TEXAS NATURAL RESOURCE CONSERVATION COMMISSION

February 2, 1999

Re: EDWARDS AQUIFER, Comal County.
PROJECT: SAC-N-PAC Store No. 604, Project number 1129.00, Located on the northeast corner of the intersection of Purgatory Road and Highway 306, Comal County, Texas
TYPE: Request for Approval of Water Pollution Abatement Plan (WPAP); 30 Texas Administrative Code (TAC) §213.5(b); Edwards Aquifer Protection Program

FINISHED SITE PLAN
SAC-N-PAC
COMAL COUNTY, TEXAS

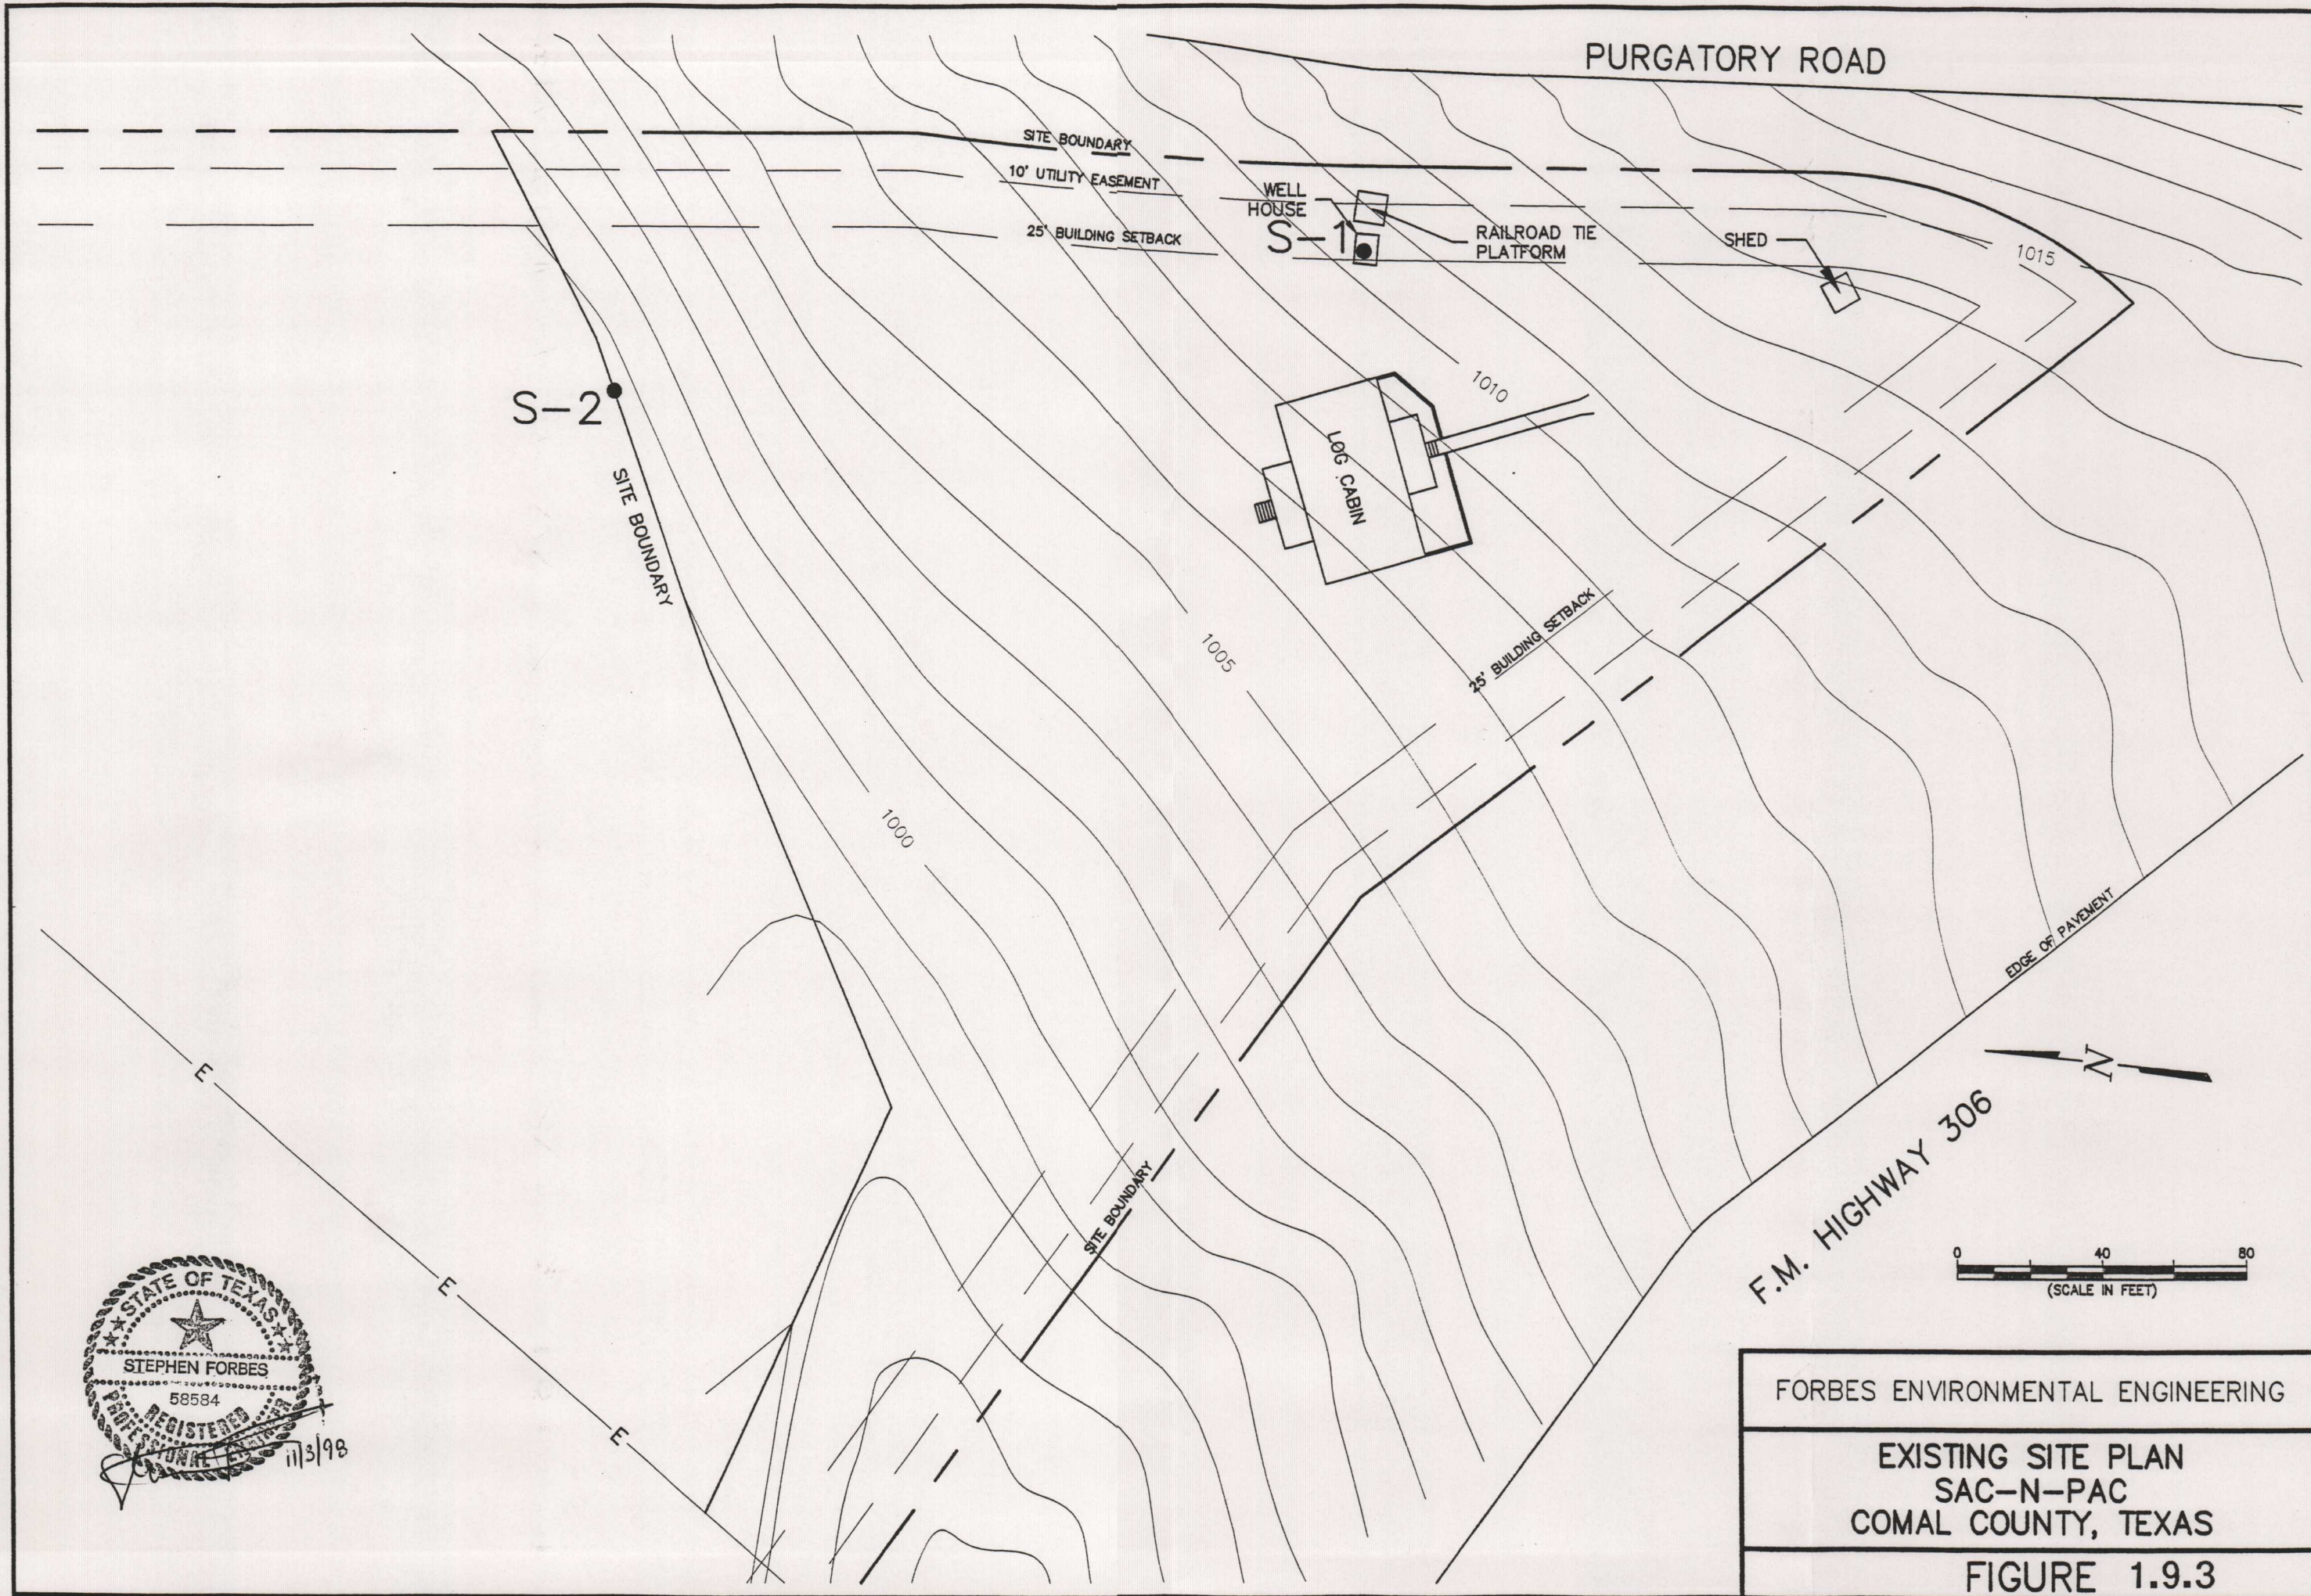
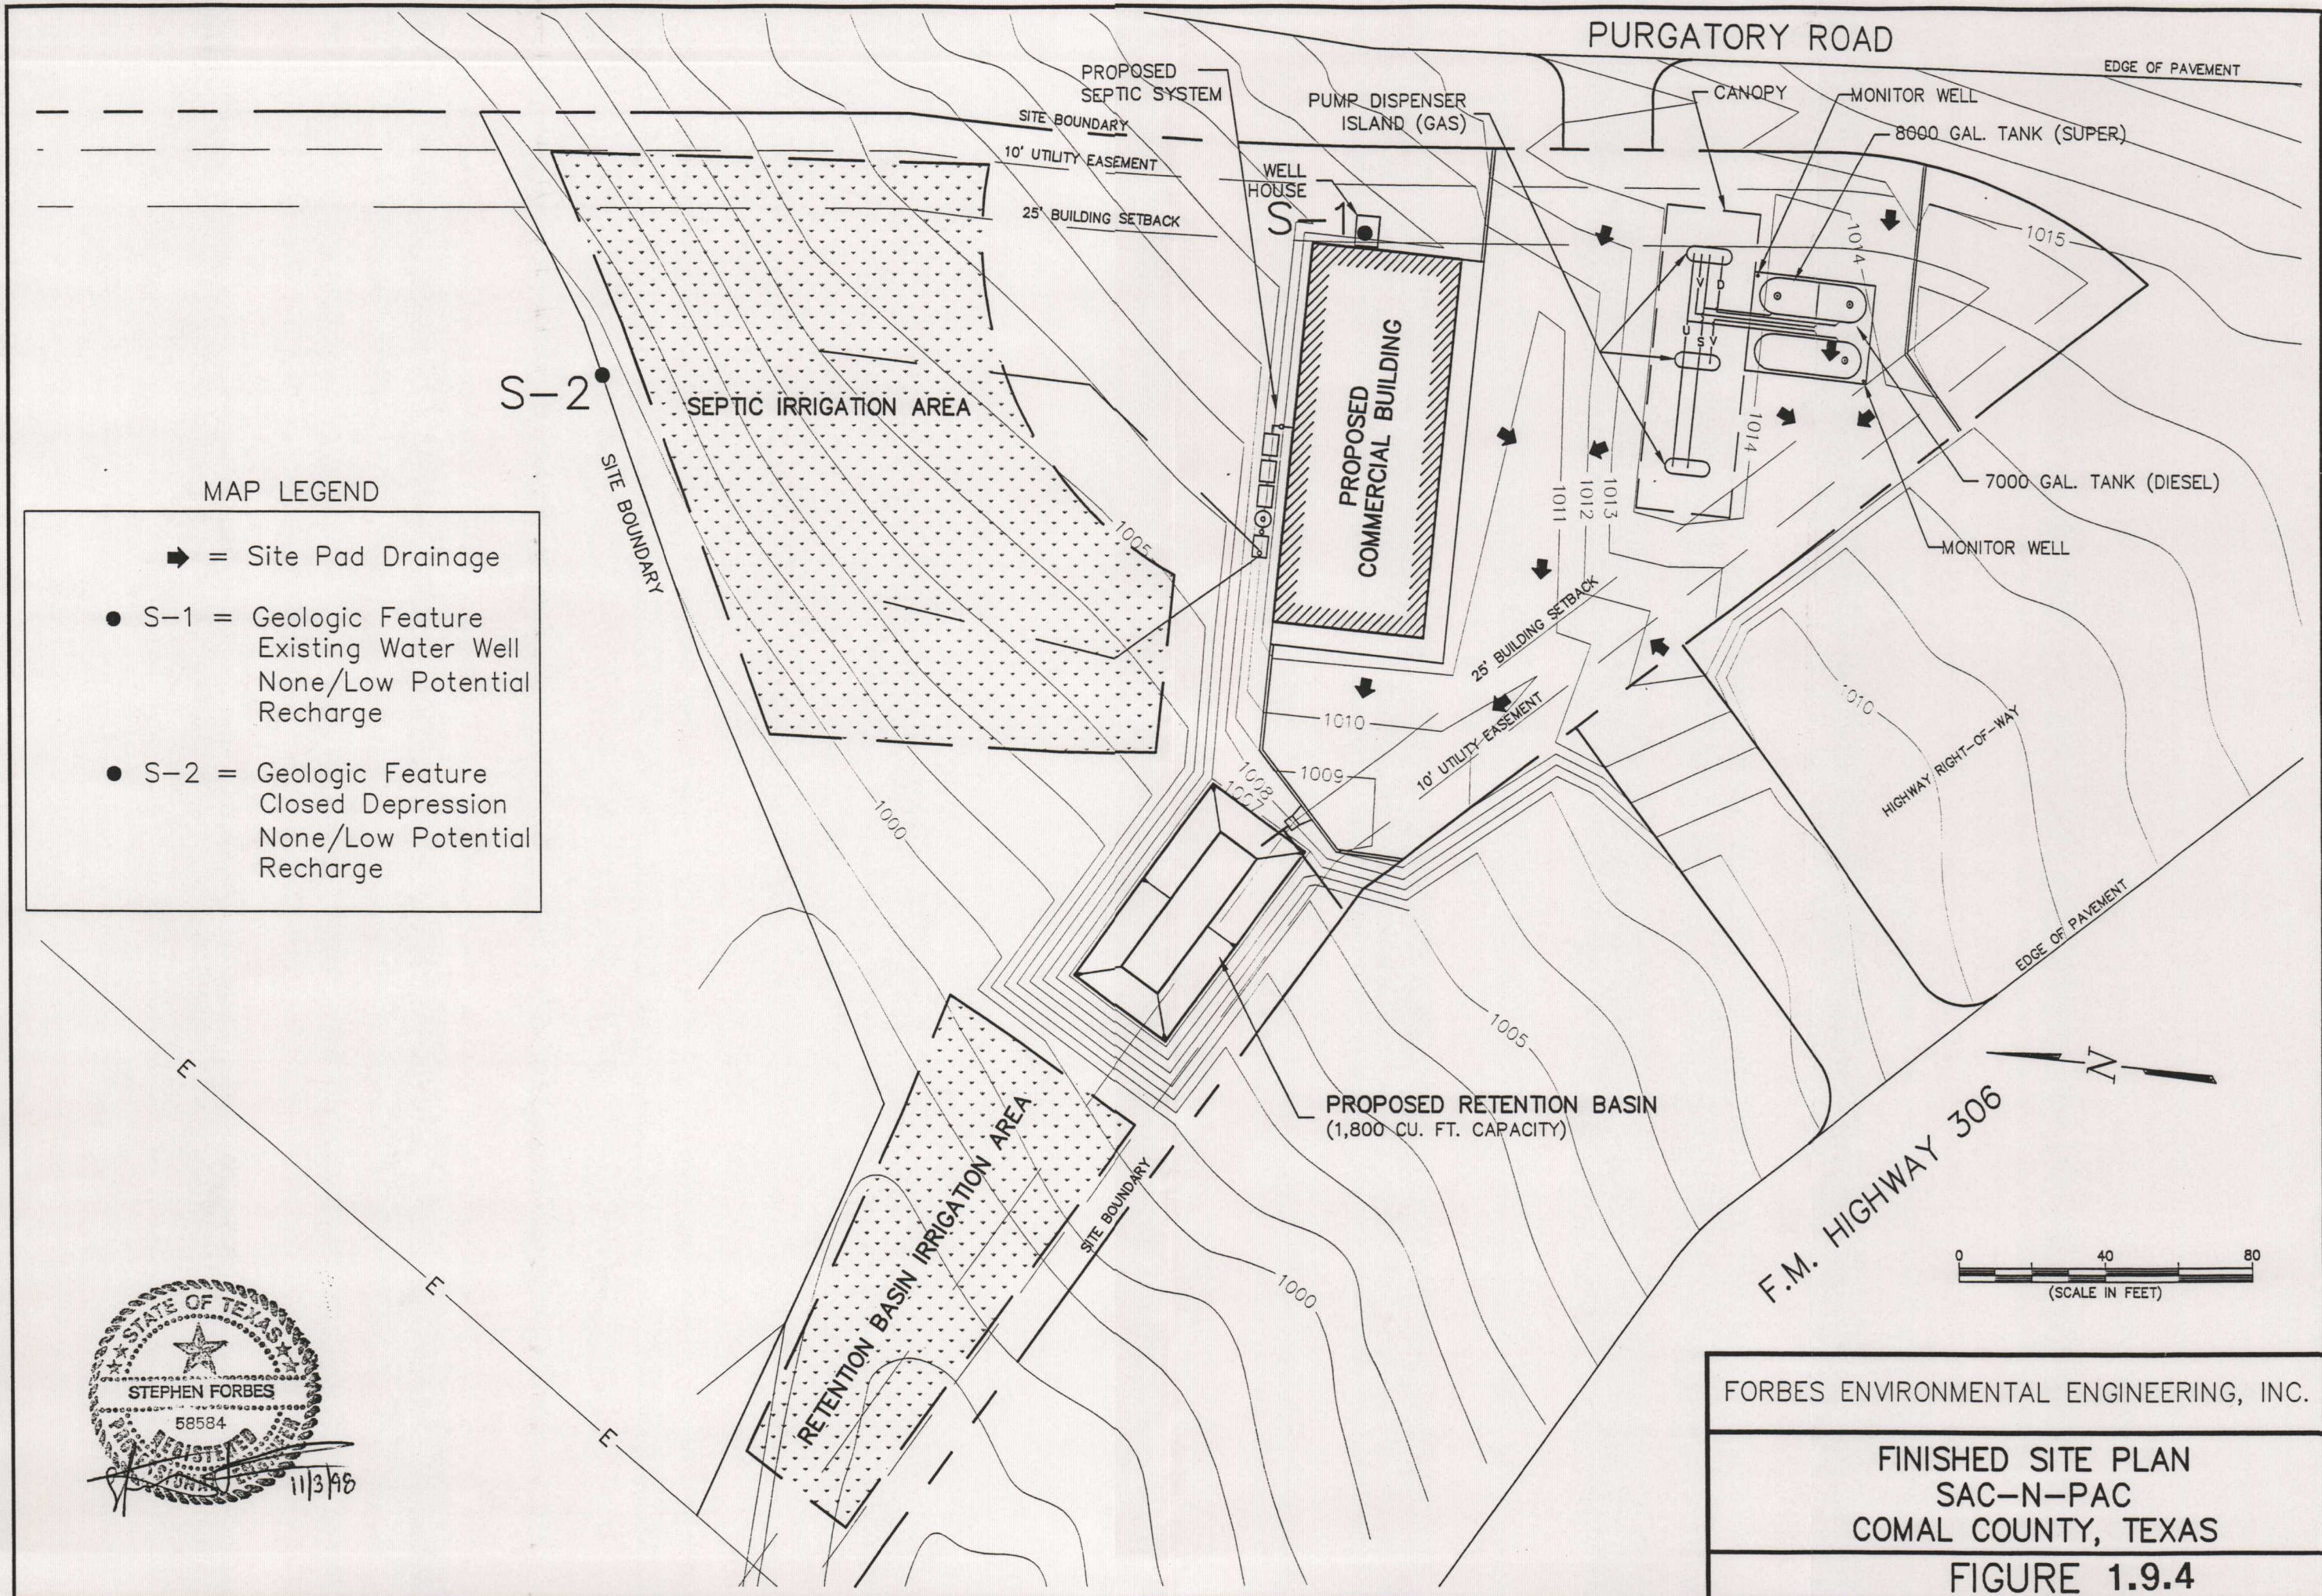
According to the geologic assessment included with the submittal, two (2) features were identified on the proposed development. The features, identified on the site map as S-1 and S-2, consisted of an existing well

and a closed depression. The well was assessed as having a "possible" sensitivity while the closed depression was assessed as "not" sensitive.

RETENTION BASIN
SAC-N-PAC
COMAL COUNTY, TEXAS

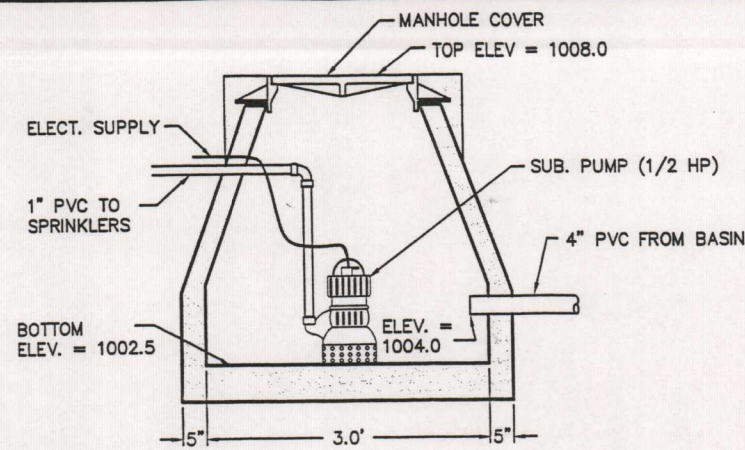
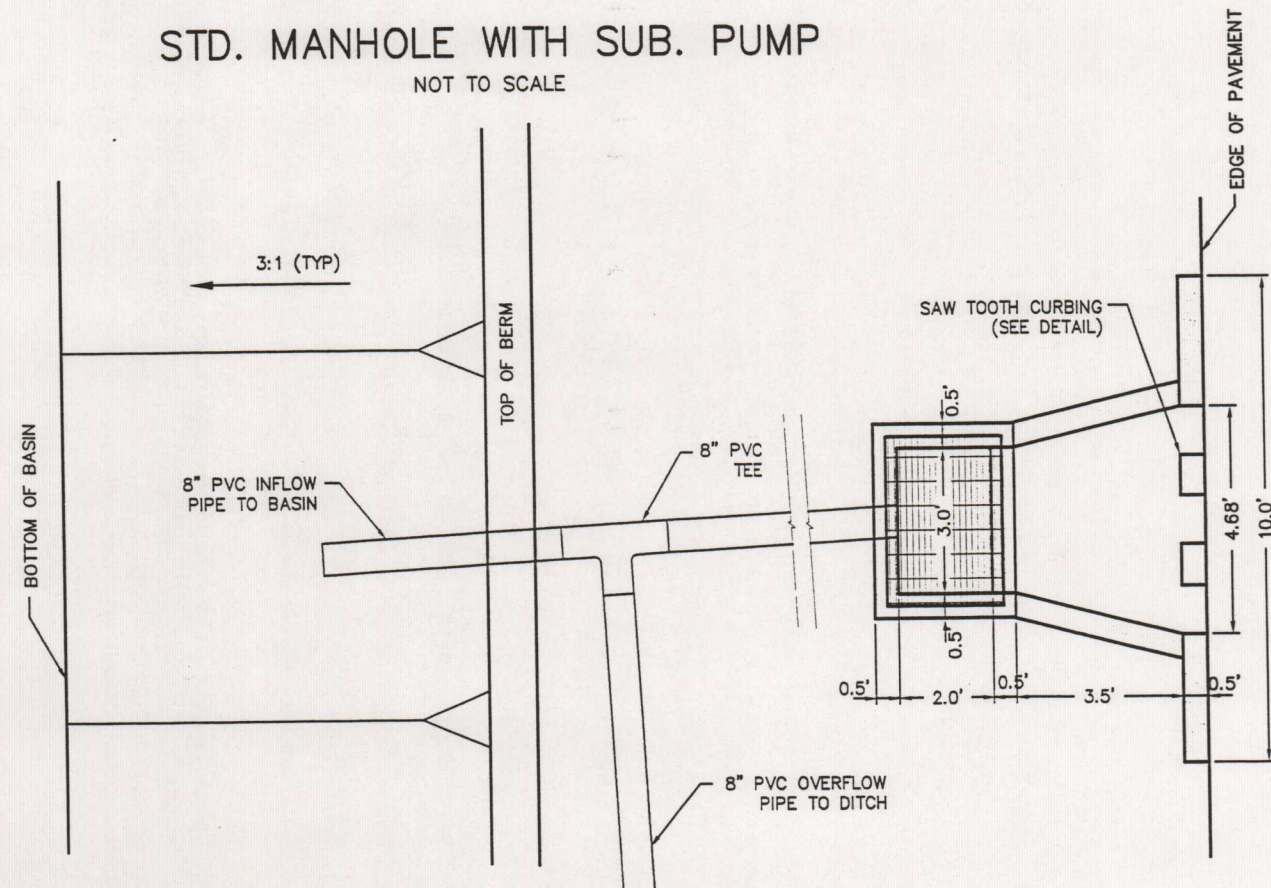
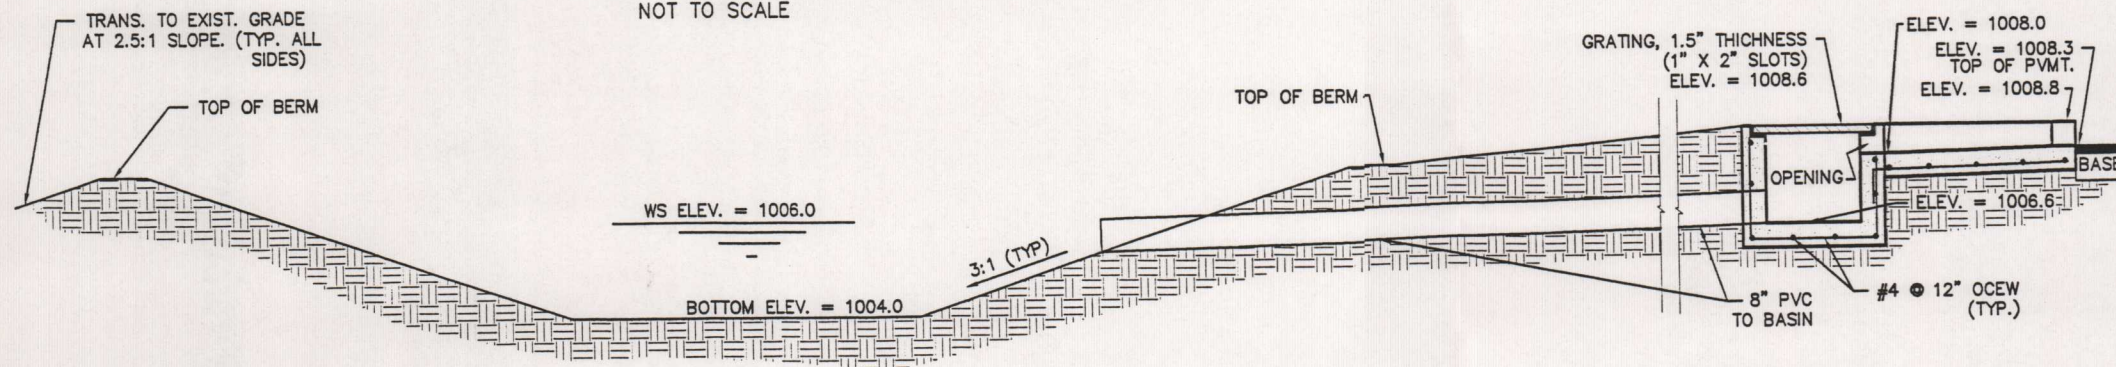
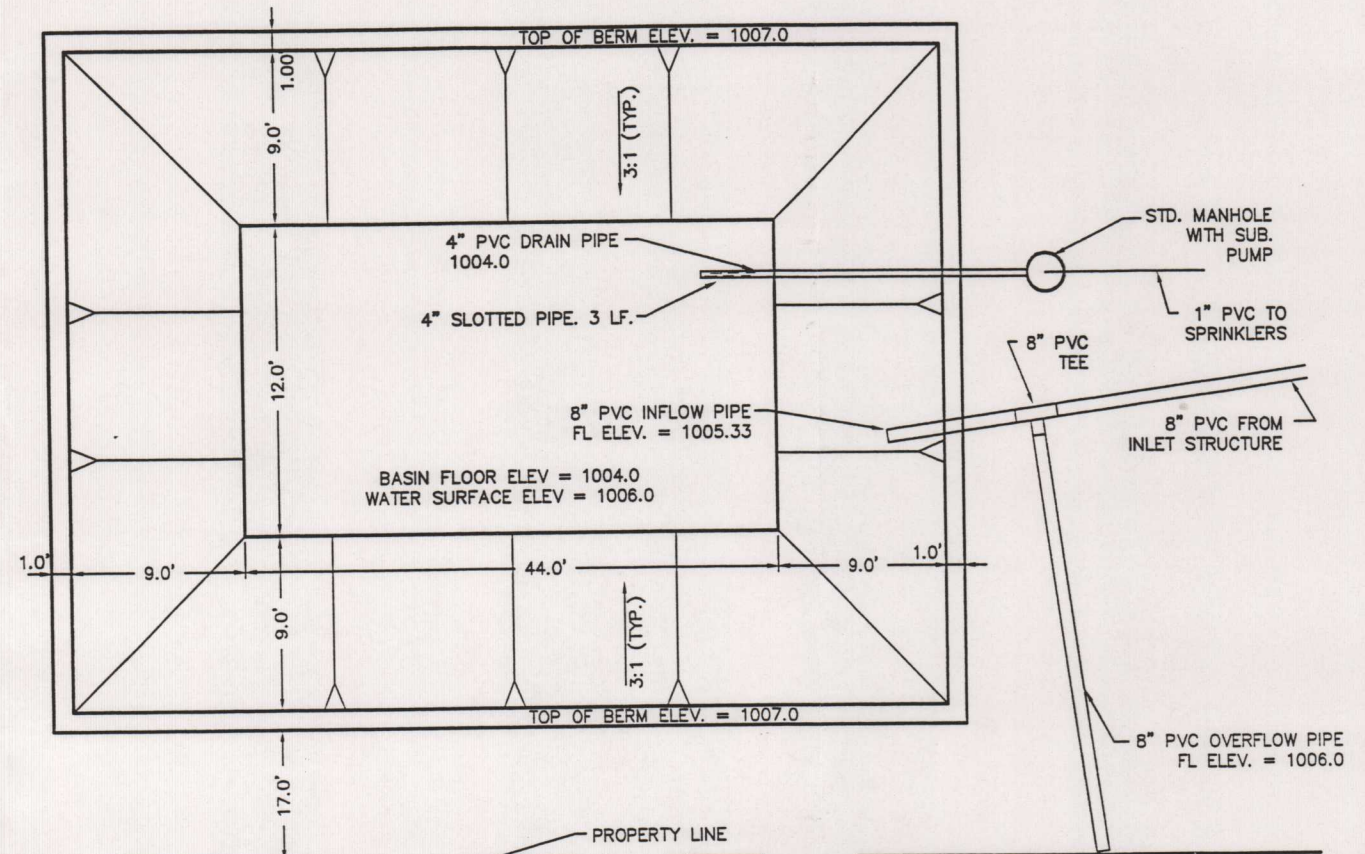
The retention basin is designed in accordance with the LCRA Lake Travis Nonpoint Source Pollution Technical Manual. It is sized to capture the first 0.75 inches of stormwater run-off from 0.56 acres of the parking lot and building. Total capture volume is 1,800 cubic feet. The retention basin will consist of:

1. side slopes of 3:1 for grass stabilized slopes.
2. bypass structure capable of conveying one-hundred year storm.
3. pond will be emptied within 72 hours after the rainfall event by evapo-transpiration and irrigation.
4. the application rate for irrigation should not exceed 0.1 inches/hour and not exceed 12 hours/day.
5. an impervious liner.

Total storage capacity of the retention basin is 1,800 cubic feet. Based on the design criteria application rate of 0.1"/hour for no more than 12 hours per day, the 0.14 acres (6,000 square feet) of vegetated area available for irrigation is sufficient.
